Summary of Changes from 2005 Edition

2008 Entergy Customer Installation Service Standards (CIS)

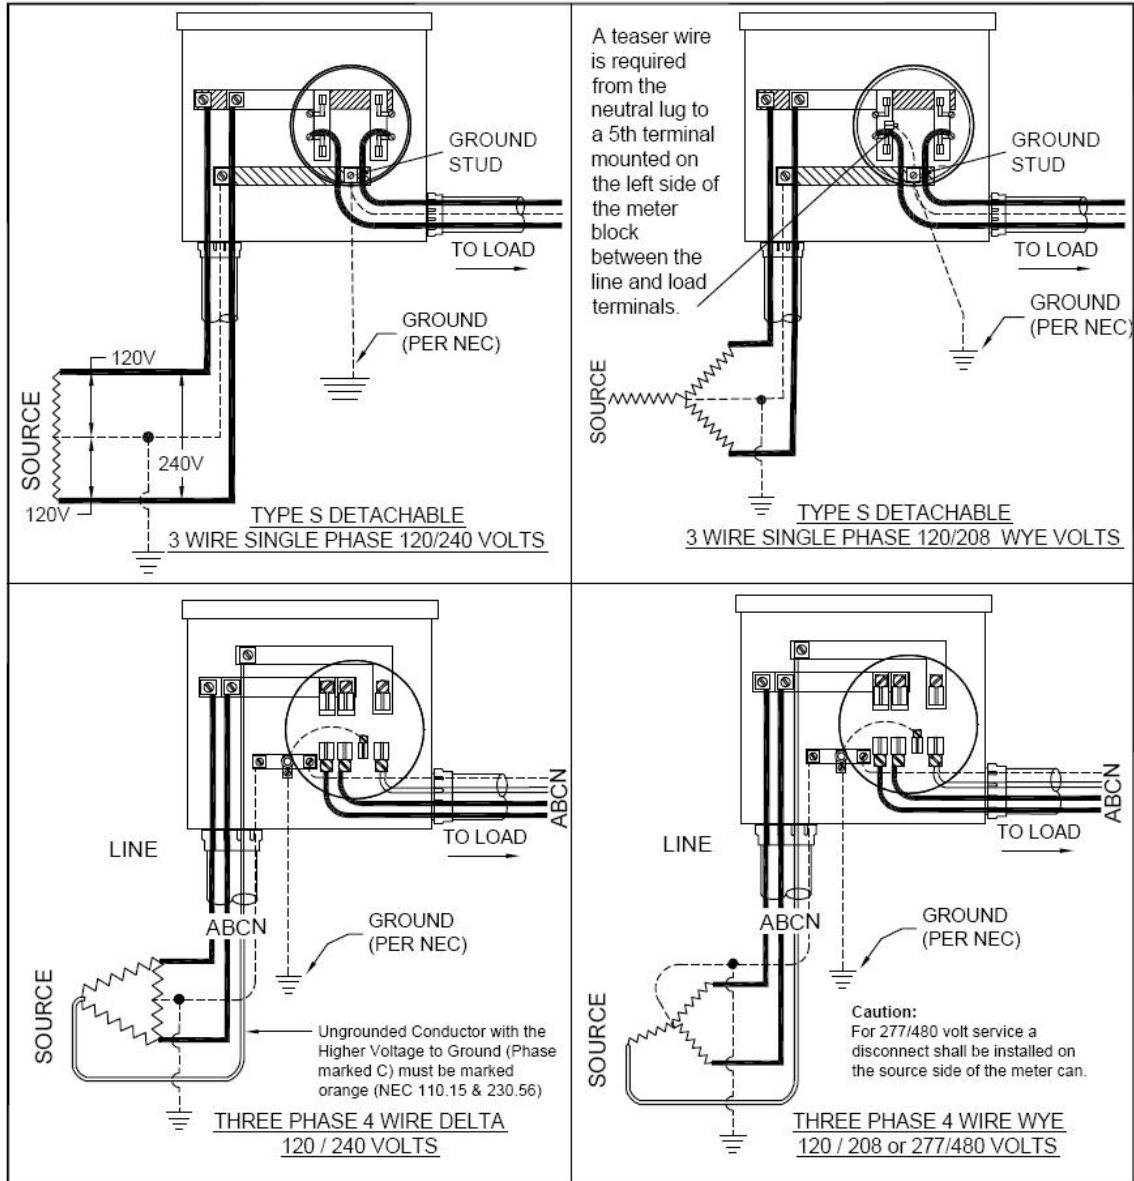
- For loads where parallel phase and neutral service entrance conductors are installed, the Customer shall consult with the Company early in the design phase to determine how many and sizing of conductors that may be brought out for their system.
- Pads mount transformers 500 kVA or smaller can accept eight conductors per phase, 750kva and larger can accept twelve conductors per phase.
- For underground service, bus duct or a Customer furnished Company approved junction box should be required for loads that exceed the number of conductors the Company can accept.

ENTERGY SERVICES, INC.			
WIRING DIAGRAM CONNECTIONS FOR UNDERGROUND SELF CONTAINED METERS			
APPROVED BY:	JRH	DATE:	APRIL 2005
CHECKED BY:	JED	SCALE:	NONE
DRAWN BY:	DAT		
		No. SS11.8-2	
NO.	DATE:	PLOT	1=1 SH. 2 OF 2

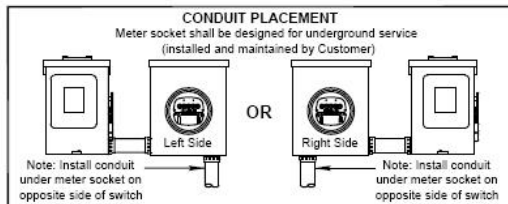
- Drawings to comply with NEC 300.34 Conductor Bending Radius, drawings to greater specify meter bases for underground feed services have been added. (Drawing SS11.8-2 shown on next page)

1. All diagrams on this drawing show connections when the switch is installed on the right side (see Right Side below) of the meter socket. If the switch is installed on the left side of the meter socket you will need to mirror this diagram (see Left Side below).
2. All sockets, except residential single phase less than 320 Amps, shall have a manual mechanical gang operated bypass switch.
3. Load and supply wires shall not cross in the meter socket (11.1.2.7)
